# HOW TO INSPECT AND REPAIR INSUFFICENT ELECTRICAL POWER TO KITCHEN SLIDE MOTOR

<b>Bulletin Type:</b>	SRP	
Bulletin #(s):	SRP 20-002	
Job Code(s):	If affected unit has warranty	
Flat Rate(s):	remaining, submit your claim following the normal process.

Publication Date:	May 2021	
Make(s):	JM & Entegra	
Model(s):	Seneca & Accolade	
Model Year(s):	2020

Incident:	Insufficient Electrical Power To Kitchen Slide Motor	
Affected Units:	2020 JM HL Seneca & 2020 Entegra HL Accolade	
Parts List:	<ul> <li>DC Volt Meter (Purchase Locally)</li> <li>30 amp breaker (Purchase Locally) Type 1 - 12V Auto Reset</li> <li>6 AWG Wire (Purchase Locally) White(16') Black (25') Red (30')</li> <li>6-Wire nuts (Purchase Locally) 14-6 AWG</li> <li>2 - 6 AWG #10 Ring terminal eyelets (Purchase Locally)</li> <li>1 - 6 AWG 5/16" Ring terminal eyelets (Purchase Locally)</li> <li>Wire Loom (Purchase Locally) ½" Plastic Corrugated Loom (25')</li> </ul>	
Misc. Tools & Supplies:	<ul> <li>Screw gun</li> <li>Wire Cutter/strippers</li> <li>Zip-ties</li> <li>½" Wrench Open End</li> </ul>	
Parts Return Information:	N/A

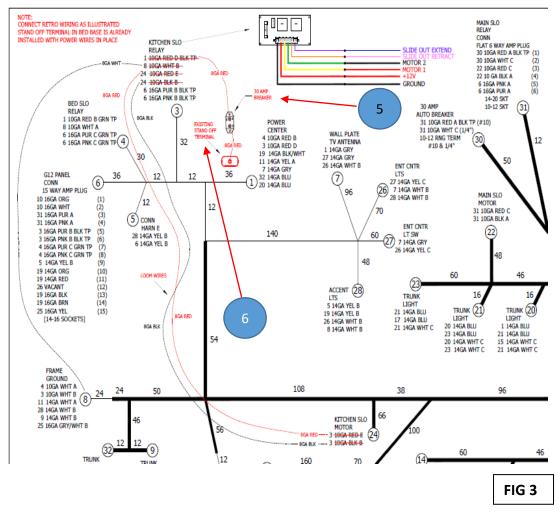
- Review slideout print shown in Fig 3. The 10 AWG wire will need to be removed and replaced with a 6 AWG wire. Add loom to wire where required to provide wire protection.
- 5. Make sure to install a 30 amp breaker with two 6 AWG #10 Ring terminal eyelets in bed box area to ensure circuit protection for kitchen slideout relay.
- 6. Use one 6 AWG 5/16" Ring terminal eyelet for the existing stand-off terminal

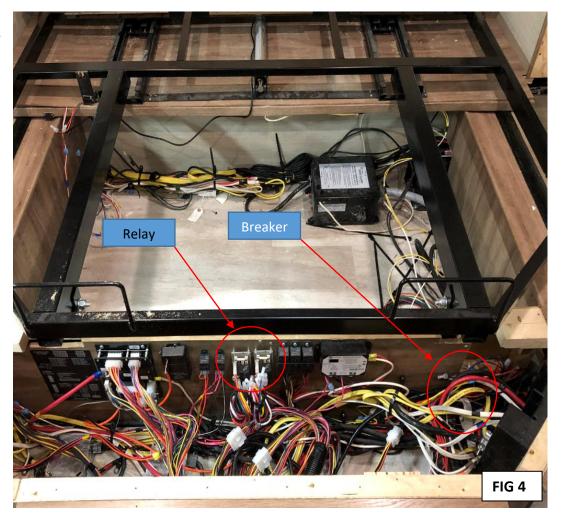
- 7. Refer to the arrows for the placement of the Kitchen slideout relay and the 30 amp breaker in the bed box shown in Fig 4.
- 8. Retest for required voltage at slideout motor access plate for the 11 to 12 volts during extending and retracting of slideout operation. This process will help run the slideout in/out normally.
